Docket Item # 4  
BAR CASE # 2010-0217

BAR Meeting  
September 1, 2010

**ISSUE:** Alterations  
**APPLICANT:** Soonja Purdy  
**LOCATION:** 600 South Washington Street  
**ZONE:** CL / Commercial

Figure 1. Plat showing location of propose units.

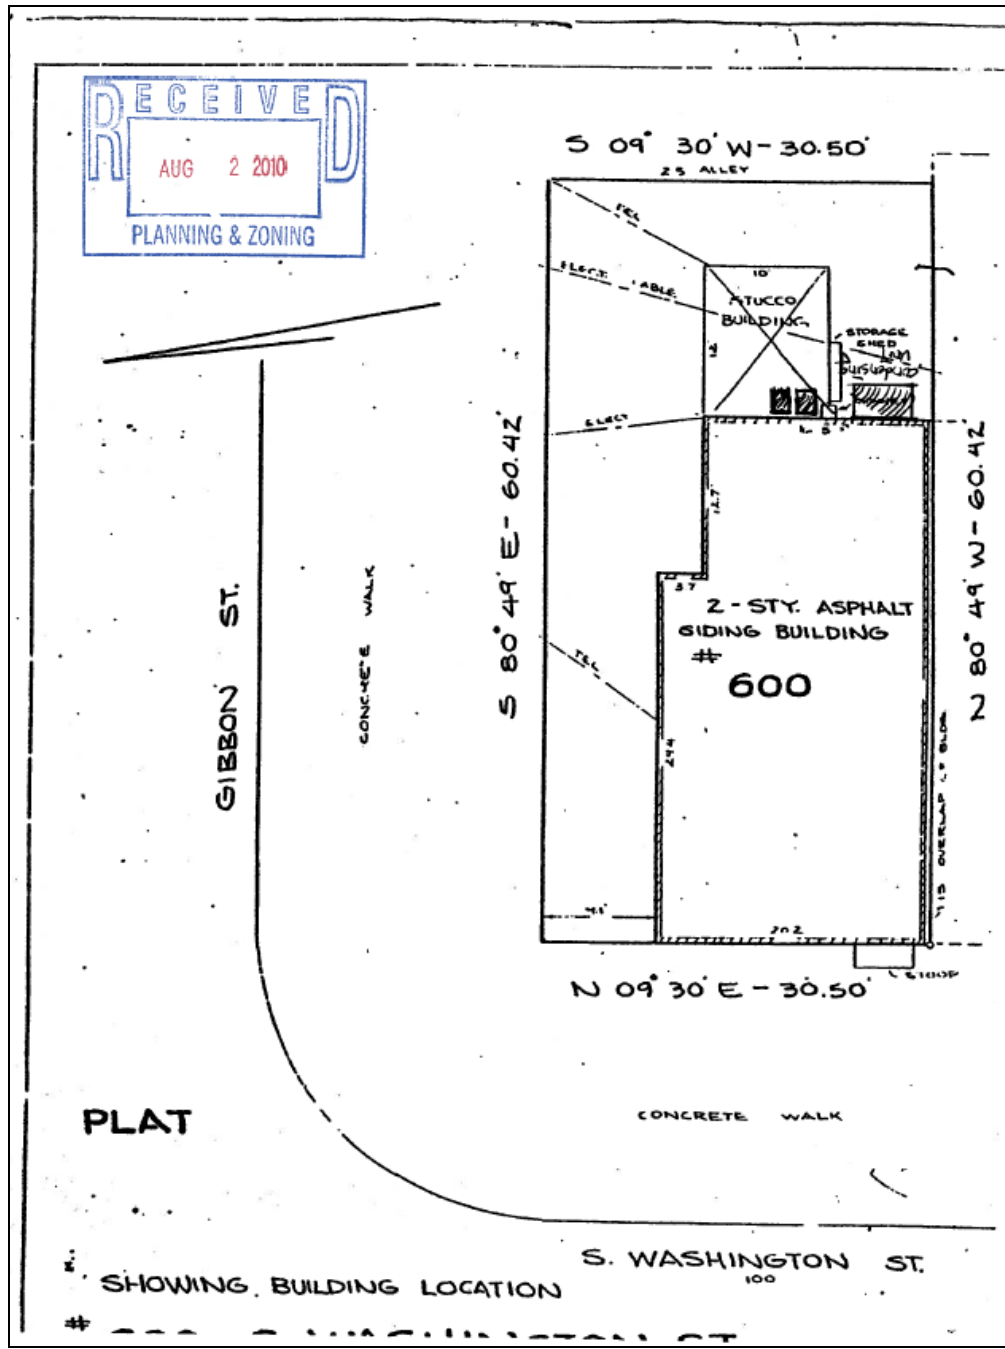
The proposed screening would be more appropriate if it screened the rear area with the concrete pad, garbage cans and the like. Staff recommends locating the fence in line with the rear ell and extending it to the rear property line. The applicant can fully enclose this rear portion if desired. As this application suggests that central AC has been installed, Staff recommends that the existing through-the-wall unit be removed and that the void be patched with siding to match the existing.

1. That the applicant work with Staff to determine an appropriate location for the rear fence to screen the HVAC, concrete pad and garbage area;
2. That the fencing be painted or stained; and
3. That the existing through-the-wall AC unit on the rear elevation be removed and the siding patched to match the existing.
